NOTICE OF PROPOSED DEVELOPMENT

PROPOSED DEVELOPMENT: TWO ASSISTED LIVING UNITS

APPLICATION NO: 5.2025-118.1

Development Application: 5.2025.118.1 Response to Request For Information - 24 Penna
Road, Midway Point - P2.pdf
Plans Reference:P2
Date Received:8/07/2025

Proposed Site Plan

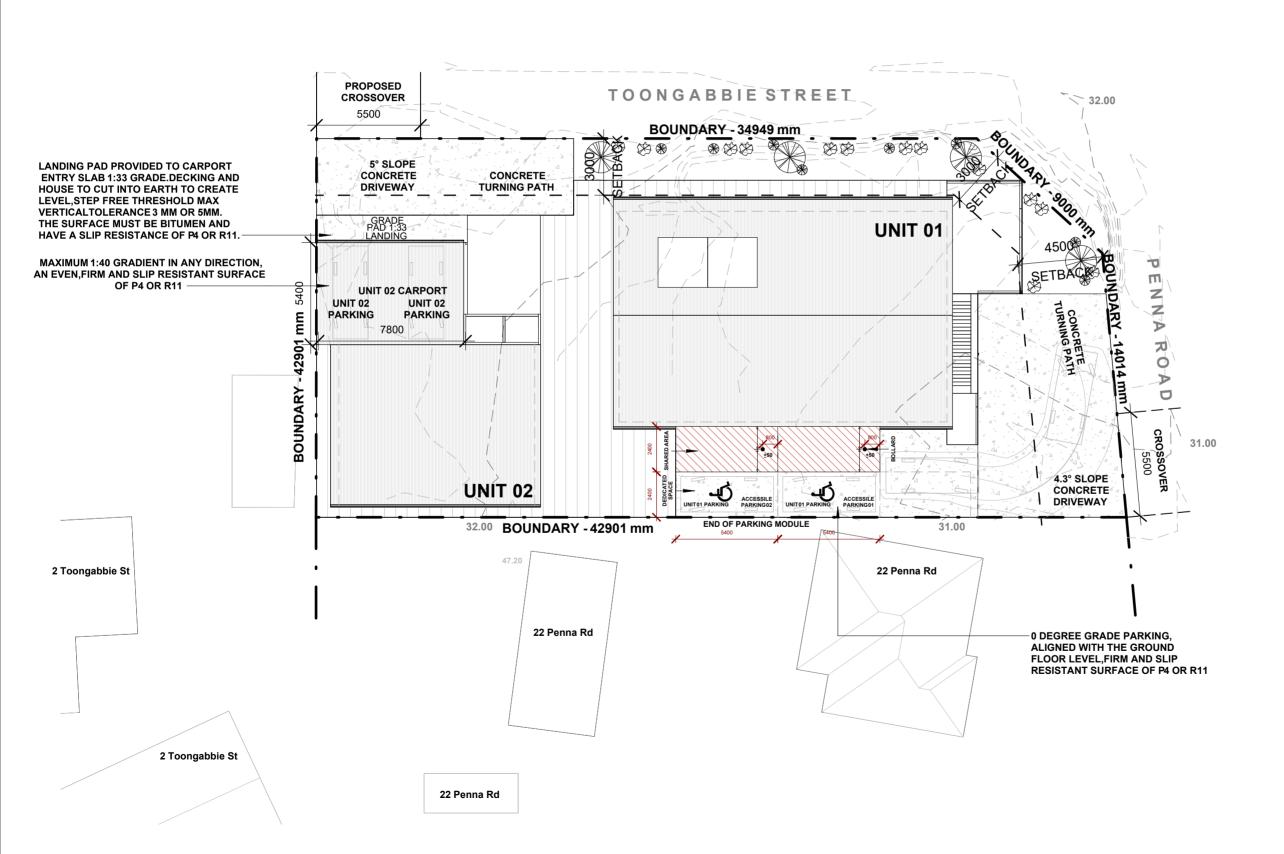
1 Please provide detail of the frontage fencing, and or confirmation of it being exempt.

Plans have been amended to demonstrate fencing meets the required exemption. All fences within 4.5m of the frontage will be less than 1.2m from NGL.

Site Plan - Building Envelope

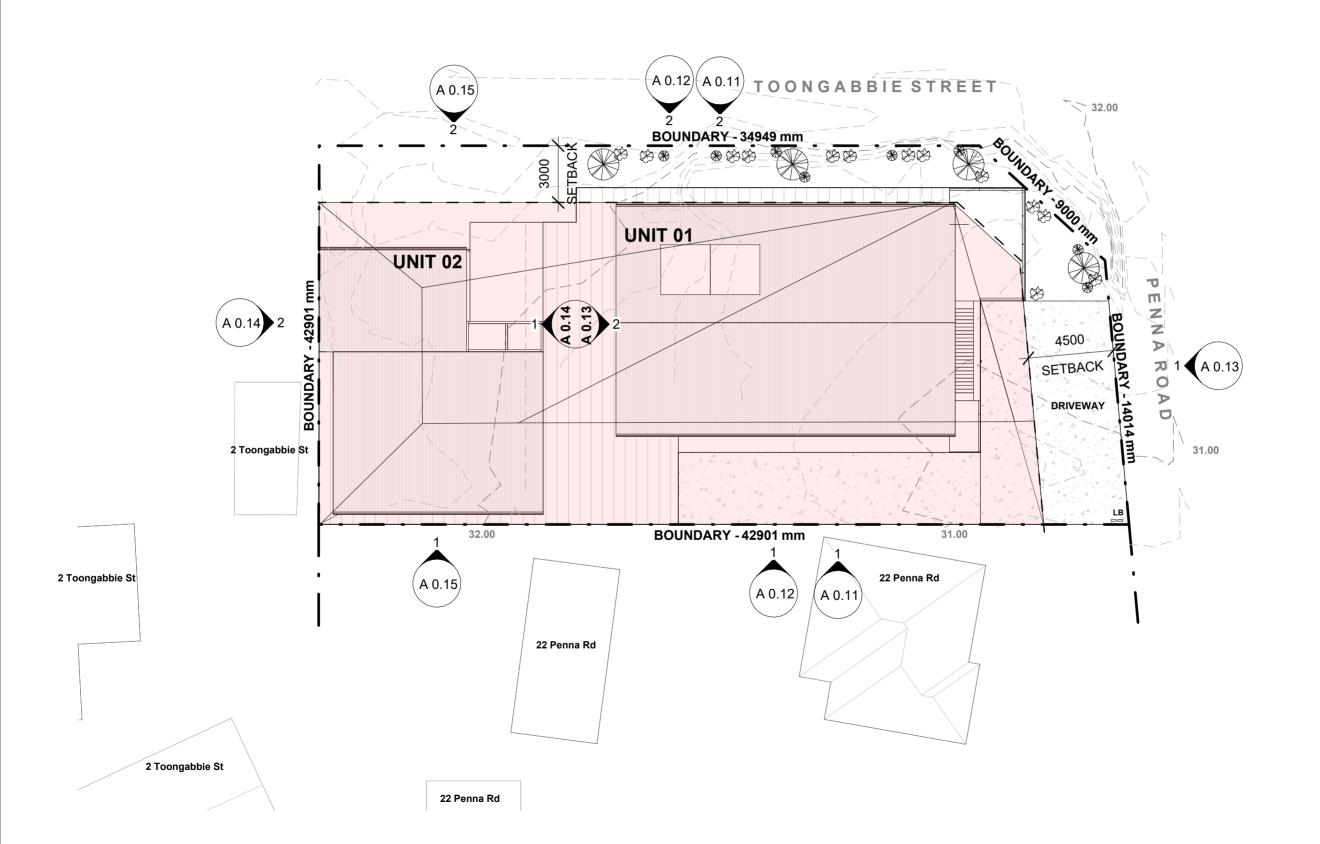
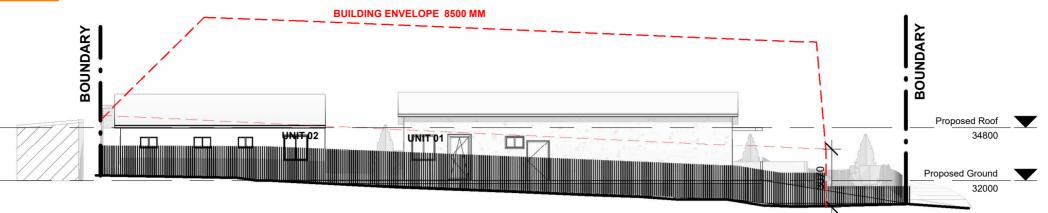
3. Please provide shadow diagrams which show the extent of overshadowing over the entirety of the adjoining properties.

NOT FOR CONSTRUCTION Drawing Title NOTES & LEGEND

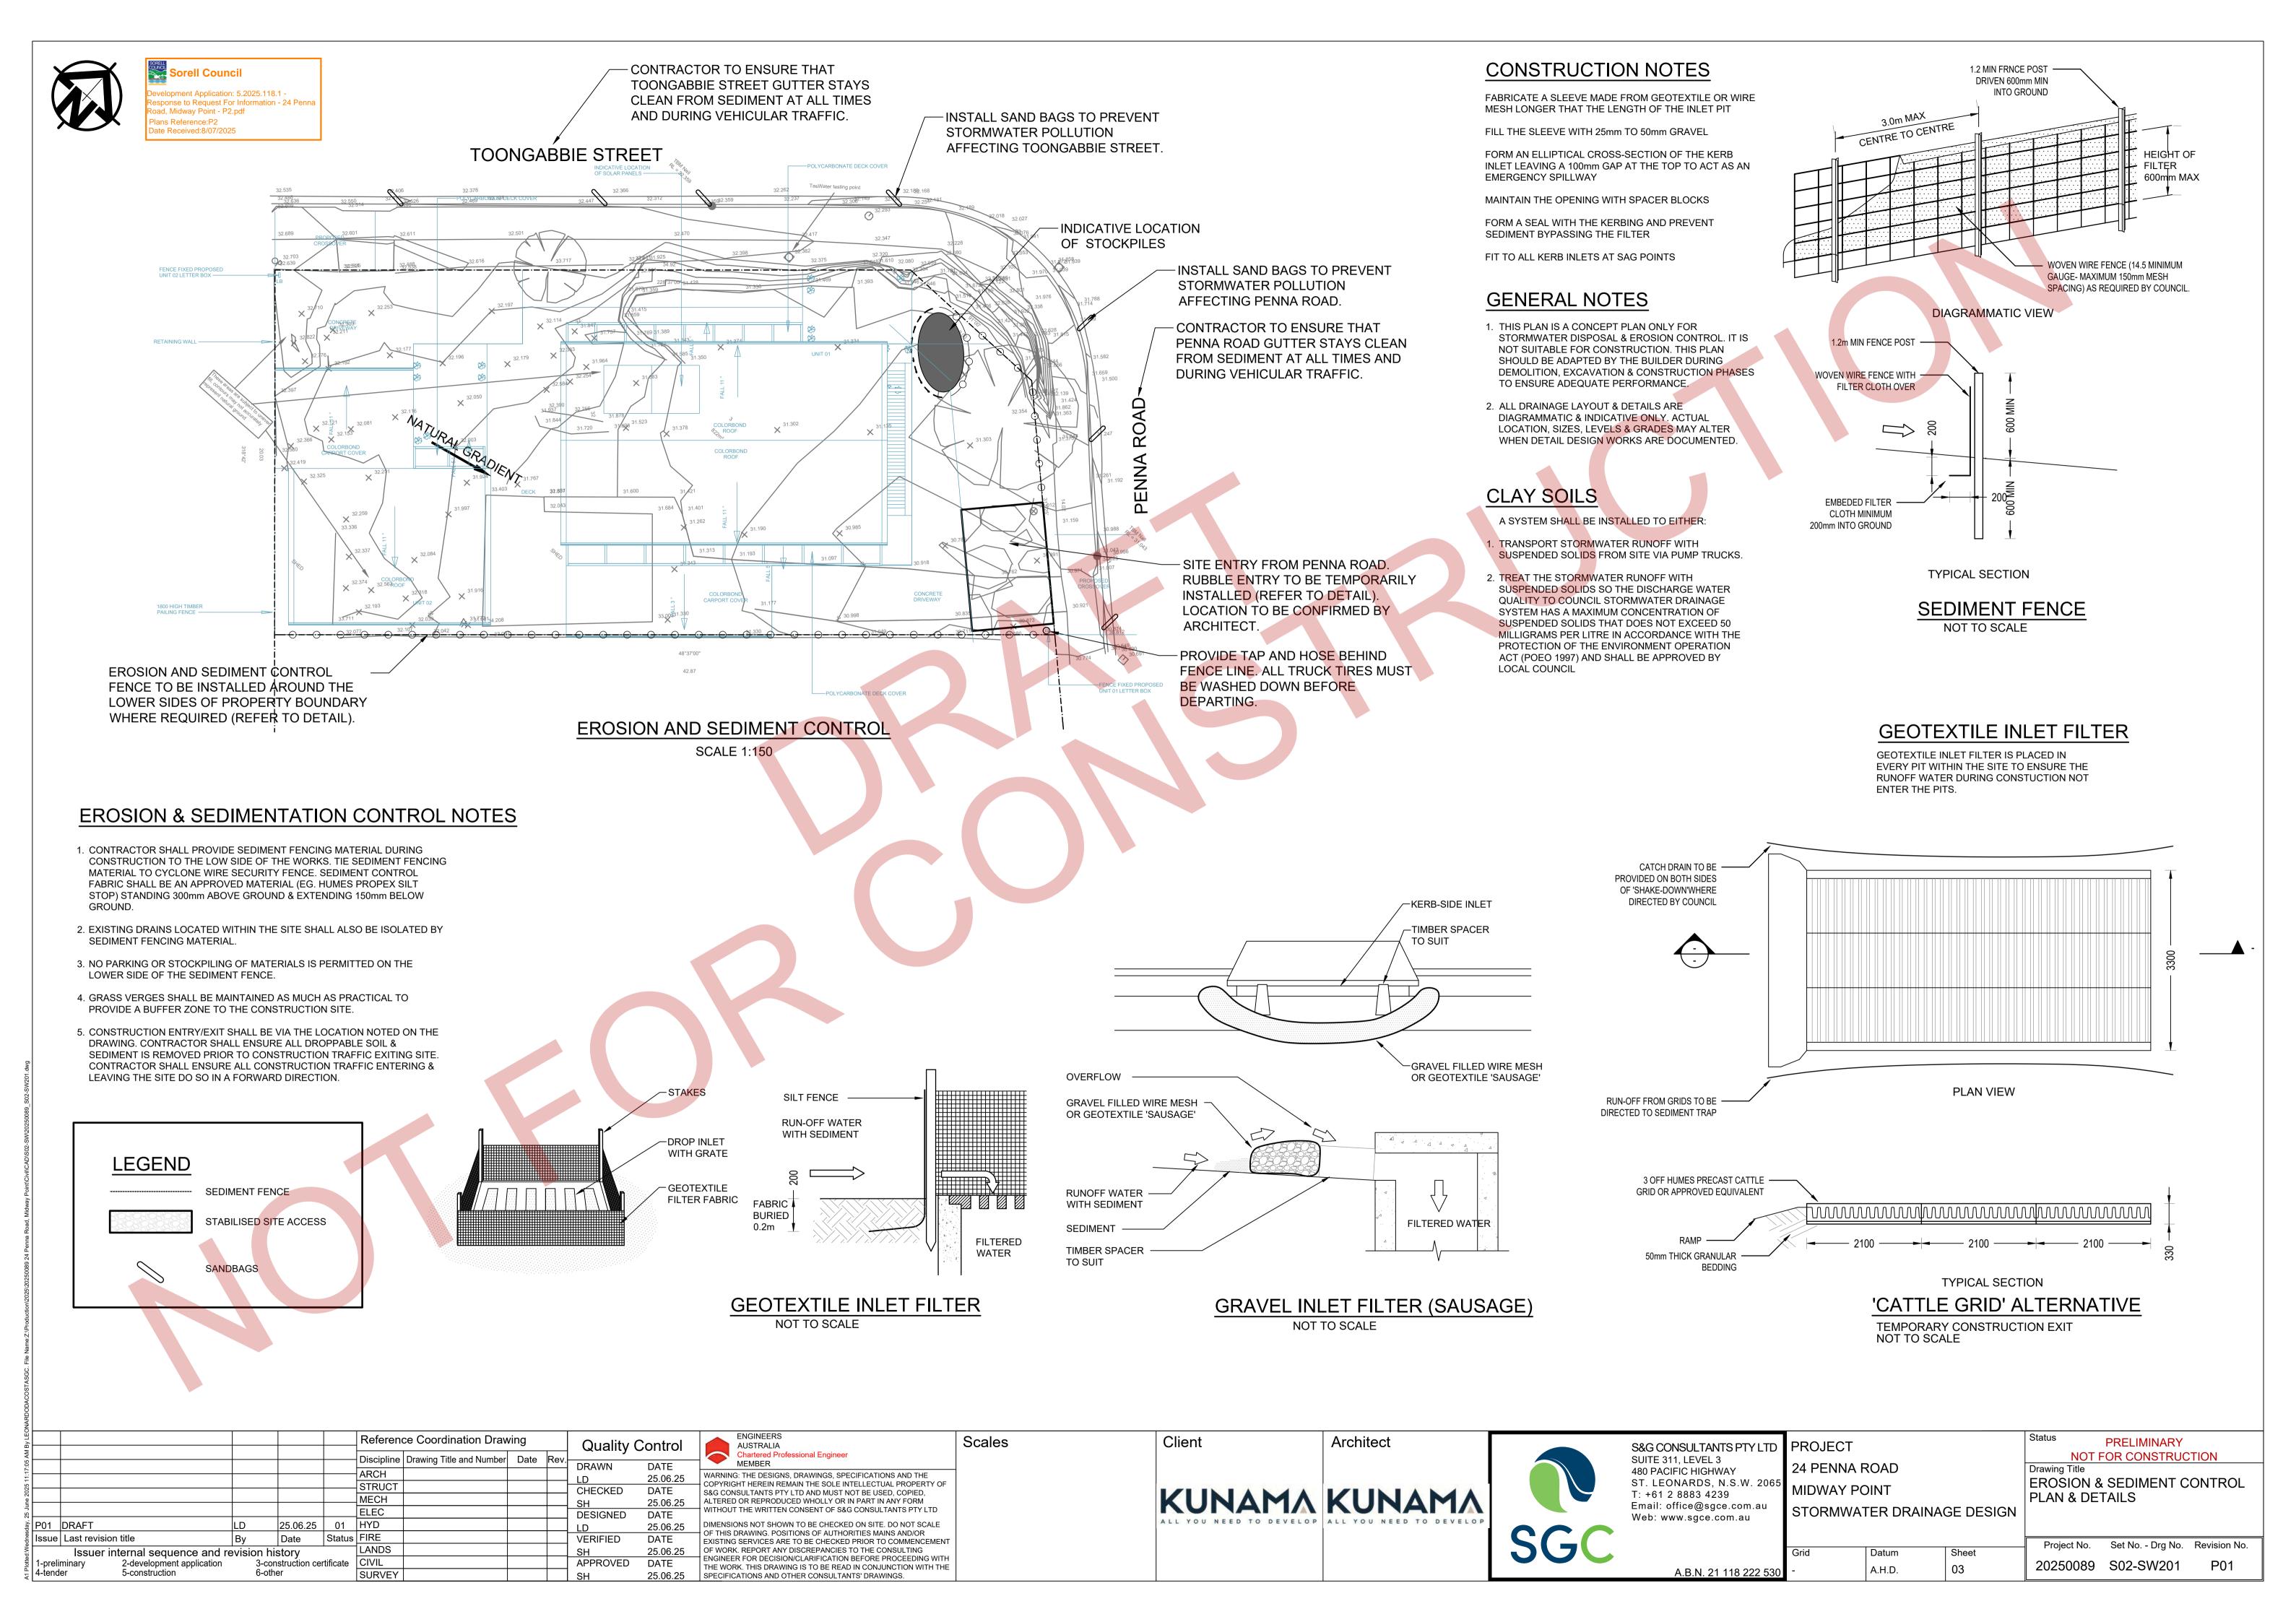
49 Tasma St, North Hobart, TAS 7000 Tel (03) 6234 9281 Fax (03) 6231 4727 Mob 0418 346 283 6. Please provide a stormwater drainage plan including connection to a council approved stormwater system.

Please refer to attached stormwater drainage design plan by SGC Consultants.
